SECTION 009113 – ADDENDUM SIX

- A. Project Name: 22034.03 Meridian High School Baseball/Softball
- B. Owner: Meridian Public School District, 1019 25th Avenue, Meridian, MS 38391
- C. Architect: Dale | Bailey, an Association, One Jackson Place, Suite 250, 188 East Capitol Street, Jackson, MS 39201-2100
- D. Architect Project Number: 22034.03
- E. Date of Addendum Five: 05 May 2023

V:\Data Partners\2023-349-00 Meridian High School Baseball_Softball_1\Production Drawings\Working\C-200 Demo Plans.dwg 5/25/2023 11:53 AM

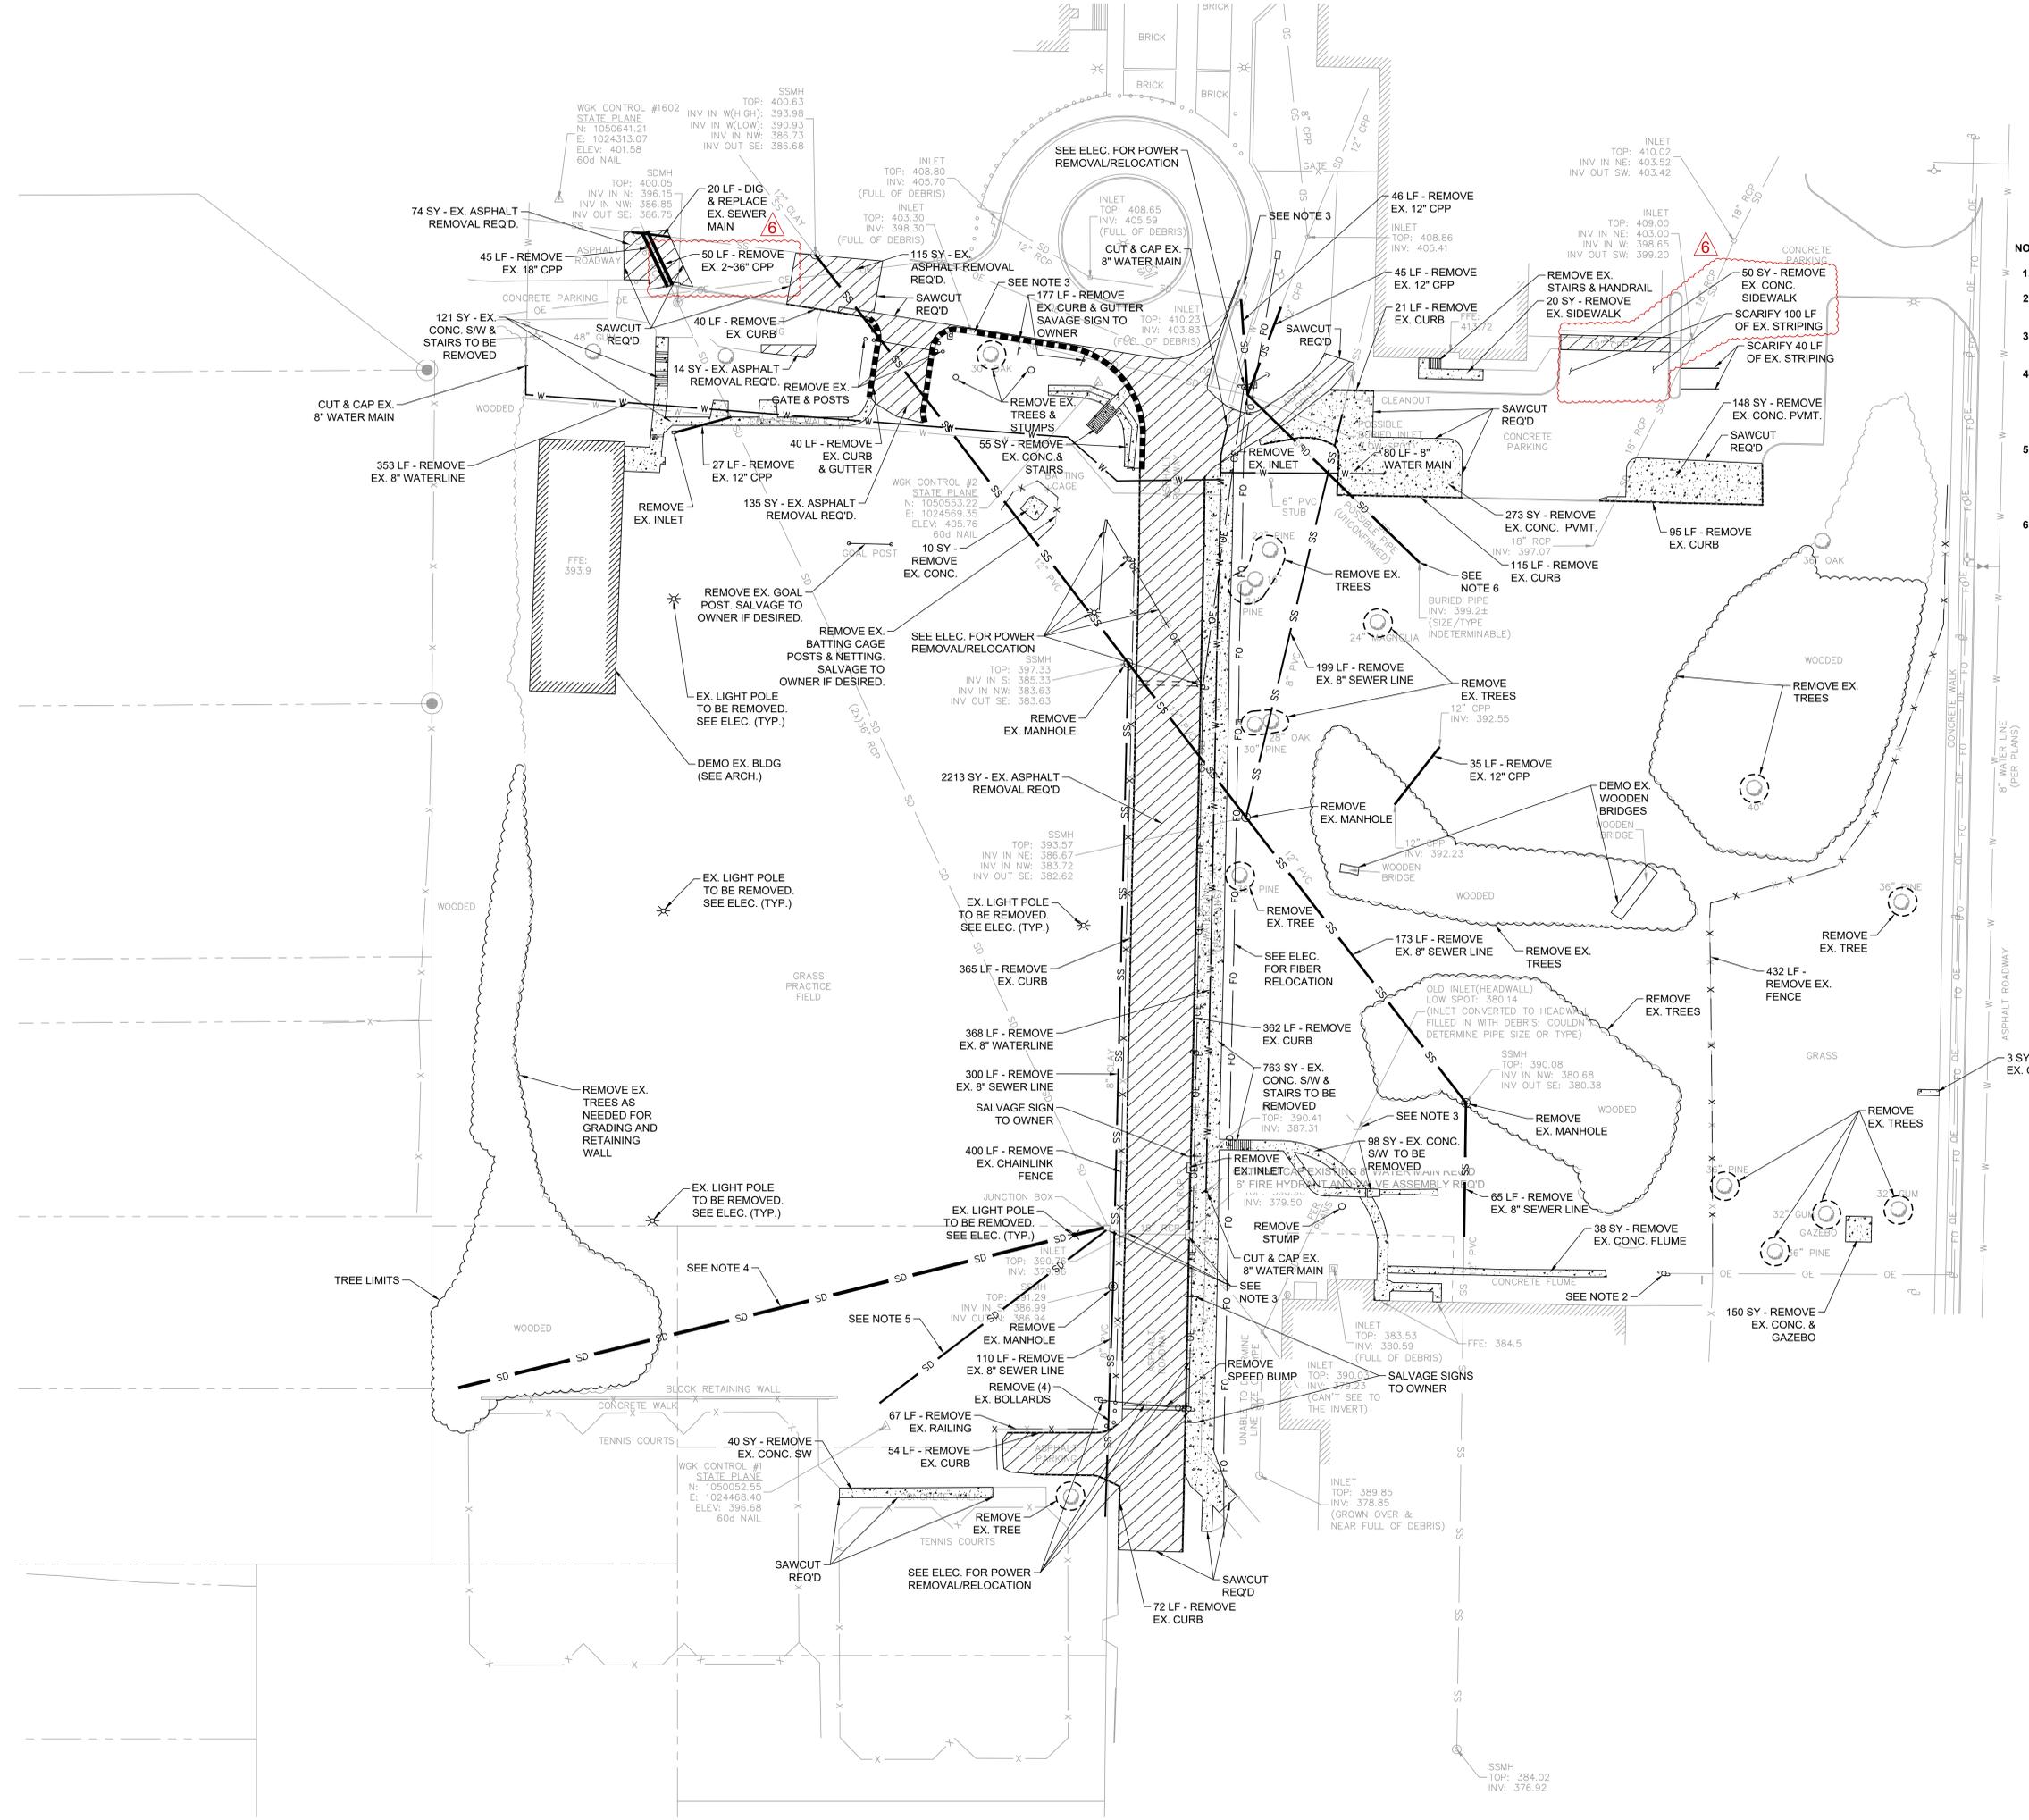
- A. C-200 – Updated incorrect pipe size and added demolition and ADA parking area
- B. C-300 – Updated to show the additional ADA parking area items of work
- C. C-303 – Updated to show the additional ADA parking area items of work
- D. C-503 – Updated to show grading points for the additional ADA parking area work
- E. C-601– Updated to show the installation of new drainage pipes that were being removed due to failure

- Modifications to be made to these drainage structures. See Civil Drainage Plan.
 - CONTRACTOR to uncover and locate existing 18" RCP, associated branch lines, and upstream end. Approximate location shown on plans. Contractor should anticipate removing 320 LF of 18" RCP but is required to locate/uncover pipe to receive final direction from ENGINEER.

- CONTRACTOR to uncover and locate existing 10" VCP/HDPE pipe, associated branch lines, and upstream end. Approximate location shown on plans. CONTRACTOR to anticipate removing 135 LF of 10" storm drain but is required to uncover & locate pipe to receive final direction from ENGINEER.

- Remove approximately 70 LF of 18" HDPE pipe from existing detention pond until concrete junction box, remove existing junction box, and an additional 44 LF of 18" RCP.
